Town of Arlington, MA Redevelopment Board

Agenda & Meeting Notice September 15, 2025

Update on Special Permits for 455 Mass Ave and 882-892 Mass Ave

Re: 882-892 Massachusetts Avenue Mixed-Use Project
Docket Number 3625

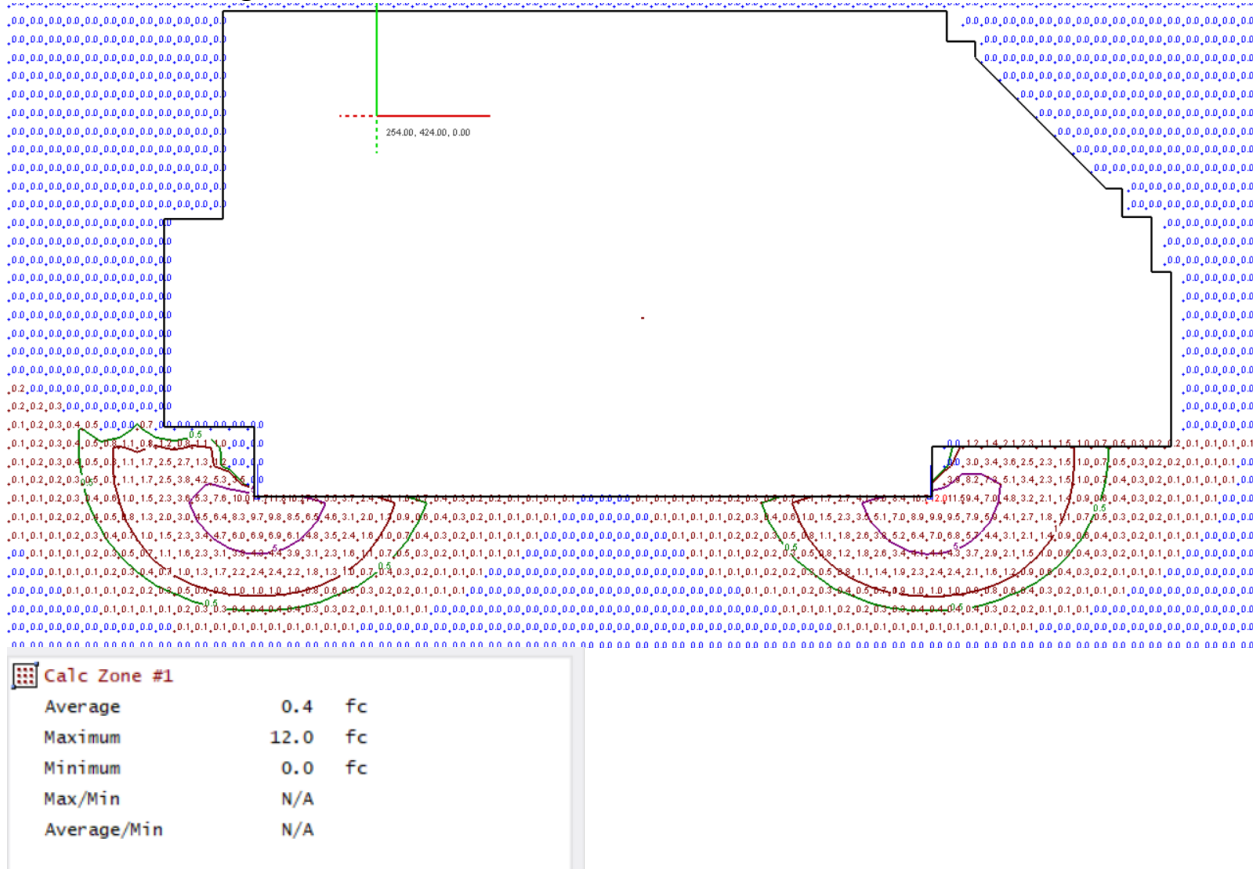
1. The lights installed on the exterior of the building at 882 Mass Avenue were manufactured by Amax Lighting (Bronze Outdoor Integrated LED Wall Pack Light), Model # LED-SL42BZ – <https://www.homedepot.com/p/AMAX-LIGHTING-180-Bronze-Outdoor-Integrated-LED-Wall-Pack-Light-LED-SL42BZ/206800621>
2. The installed lights are not Dark Sky certified, as the certification program was not instituted until 2022, but the lights are compliant with the recommendations of the Dark Sky program, ie downward facing lighting, controlled by photocell sensor built into the light, activated on a sensor from dusk to dawn, etc. Therefore, the usage is in compliance with the recommendations to avoid and reduce glare, light pollution and light trespass.

This letter is regards to the exterior lighting installation at the above listed project. The building features (2)two exterior lights at the rear of the building for the parking lot area of the property. We have provided a photometric report for the lights being utilized at the building. The photometric results for the limit of light being produced by the fixtures are represented below. A lighting level of 0.0 fc (foot candles) is achieved prior to the property lines in the parking lot area of the property. The lights installed are facing down at the grade with the shield portion facing up to sky to block lighting shining up. The lights are controlled by photocell sensor built into light.
